**WHITE LAKE TOWNSHIP
INTER-OFFICE MEMORANDUM
COMMUNITY DEVELOPMENT DEPARTMENT**

**SUBJECT: Culver's
Preliminary site plan approval**
Property described as parcel number 12-20-276-035, located on the north side of Highland Road (M-59) and west of Bogie Lake Road, with a project area on the parcel consisting of approximately 1.69 acres, currently zoned (PB) Planned Business District.

RE: Culver's- Preliminary Site Plan Review – 2nd Review

RE: Culver's
Preliminary Site Plan – Review #2

sheet: **A-3**

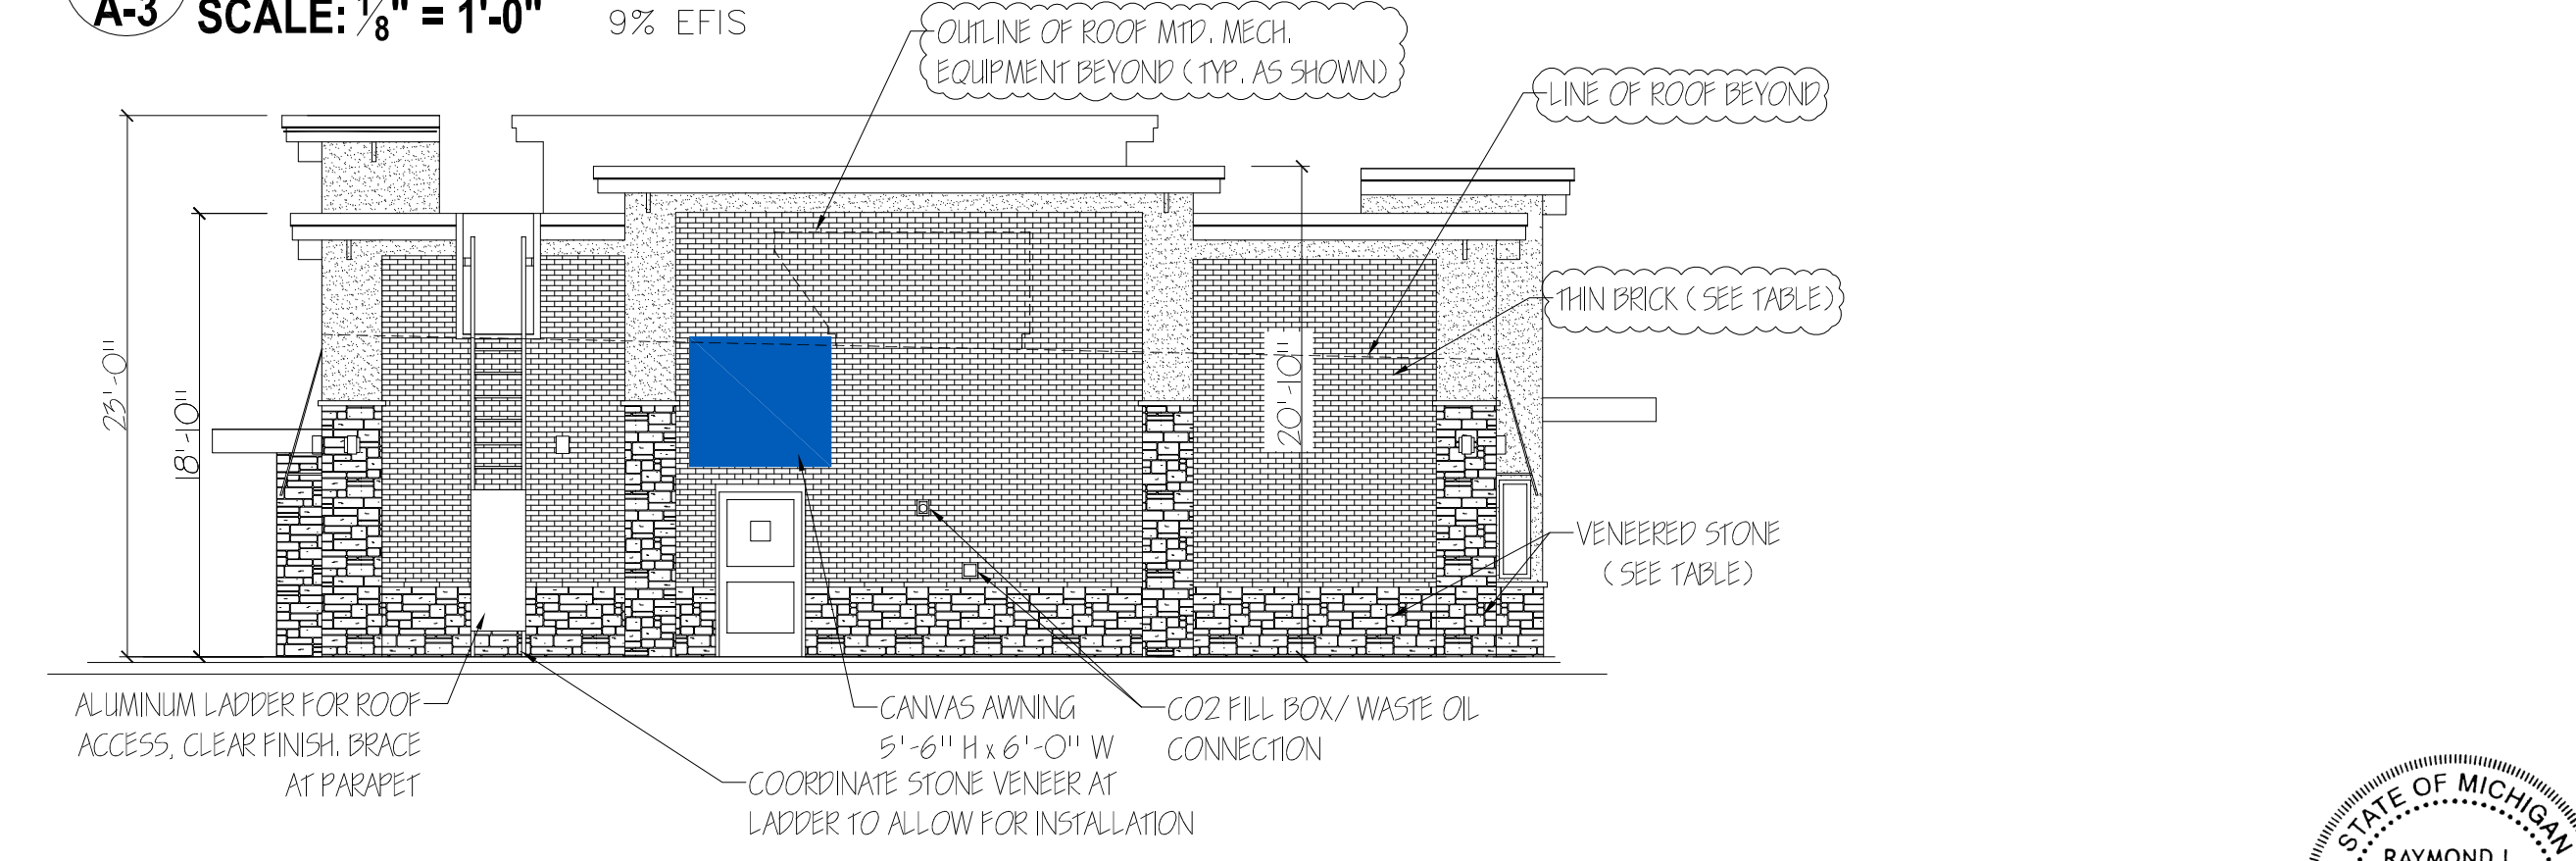
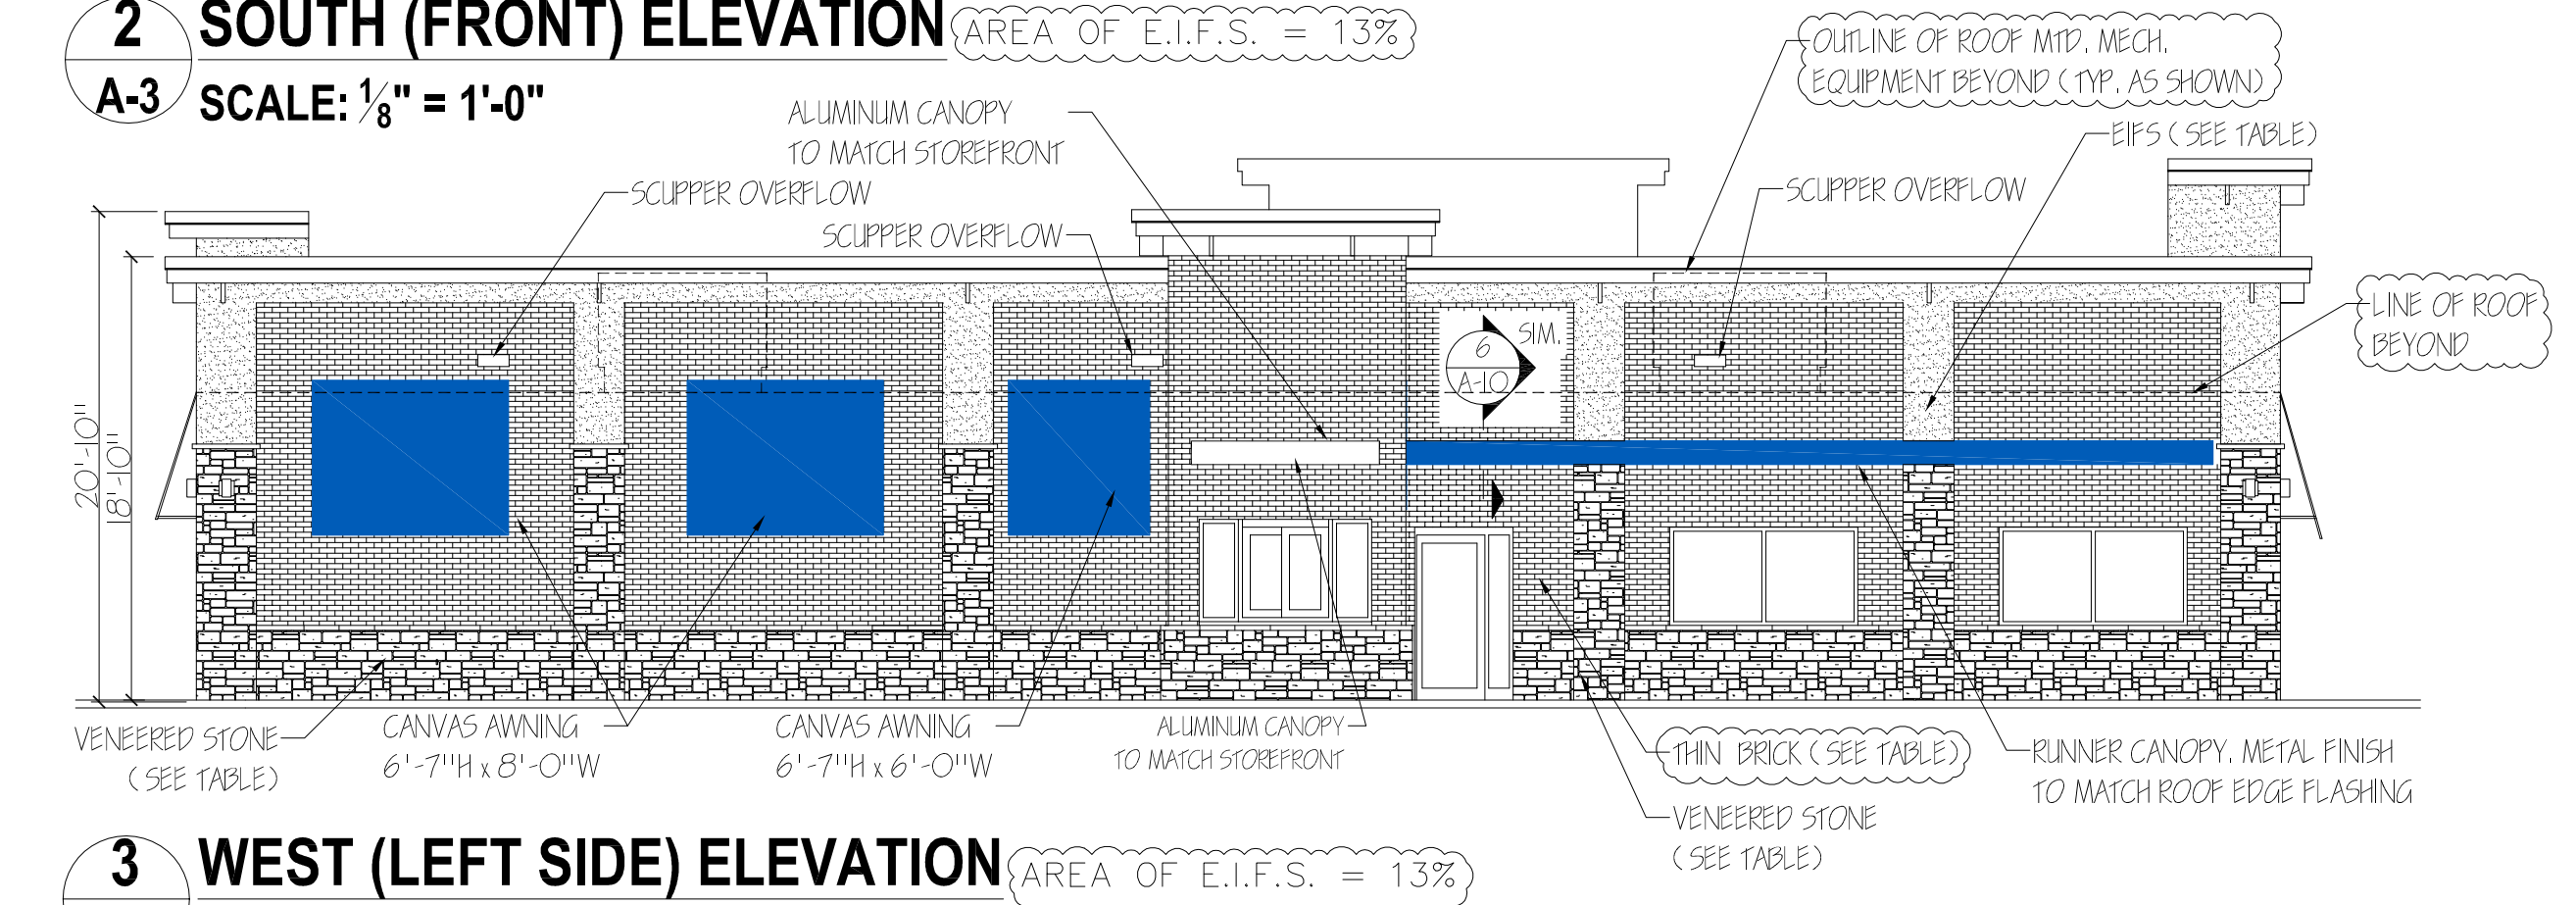
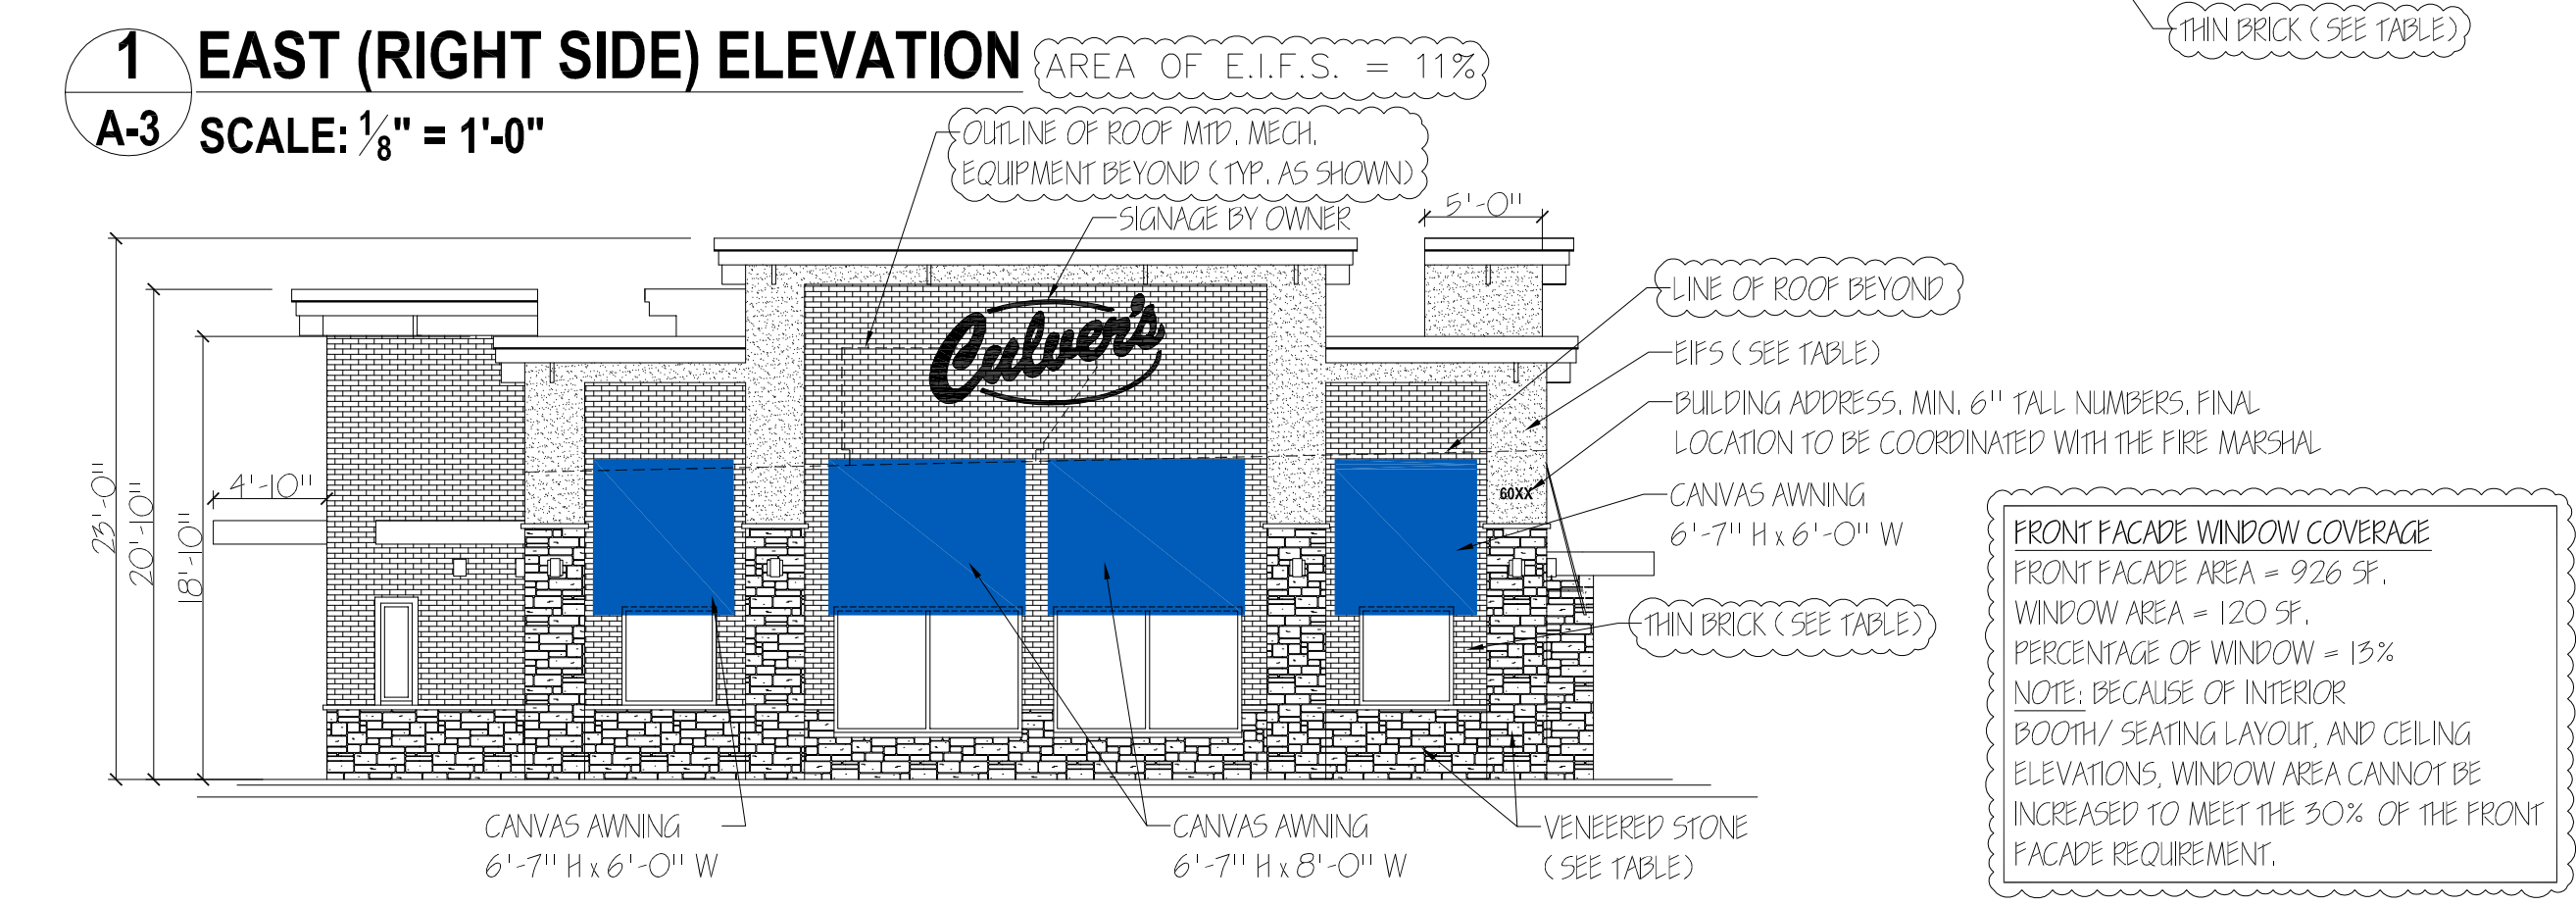
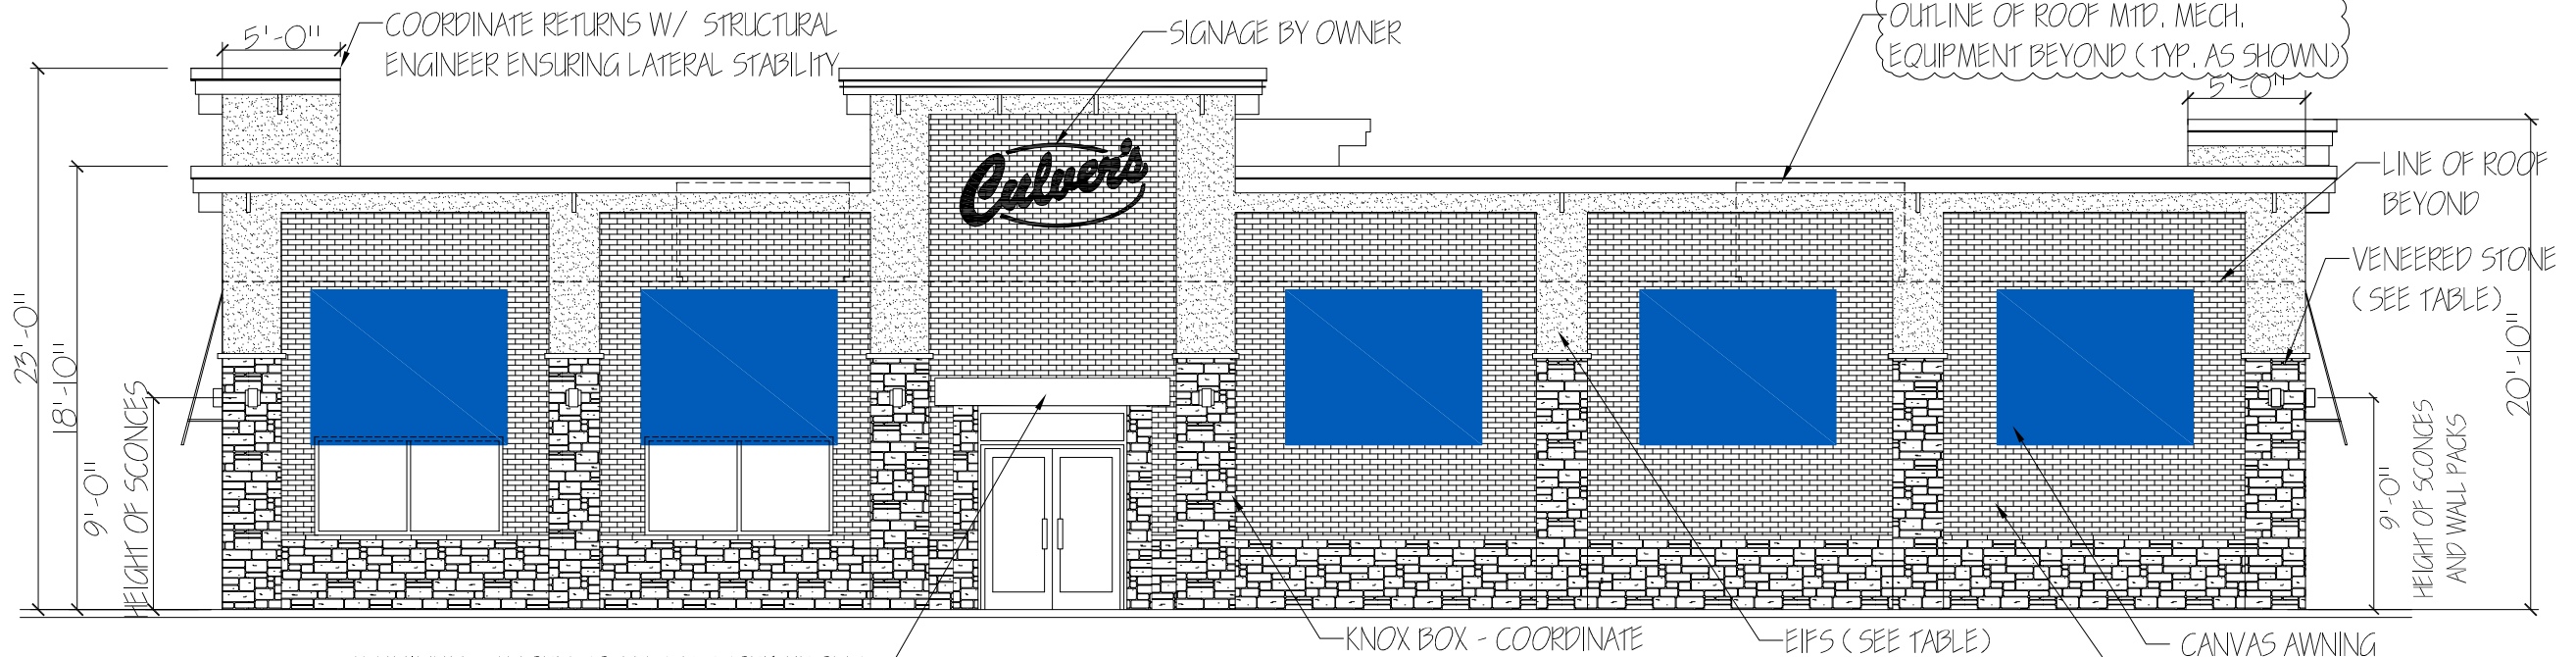
A sample board of building materials to be displayed at the Planning Commission meeting and elevations in color are required by the Zoning Ordinance and must be submitted at final site plan. (Comment remains as a notation). Additionally, the address (street number) location shall be shown on the building. Six-inch-tall numbers visible from the street shall be required. (Comment addressed. Address location has been depicted on the south building elevation). The address location is subject to approval of the Fire Marshal. (Comment remains as a notation. This requirement is noted on Sheet A-3).

The exterior elevations of all four sides of the building indicate the cornice contains optional blue LED accent lighting. Trim accent lighting at or above the roofline is prohibited signage and a waiver would be required to install such lighting. Staff suggests Sheet A-3 be revised to remove the optional blue LED accent lighting. (Comment addressed. The blue LED accent lighting has been removed from the building elevations).
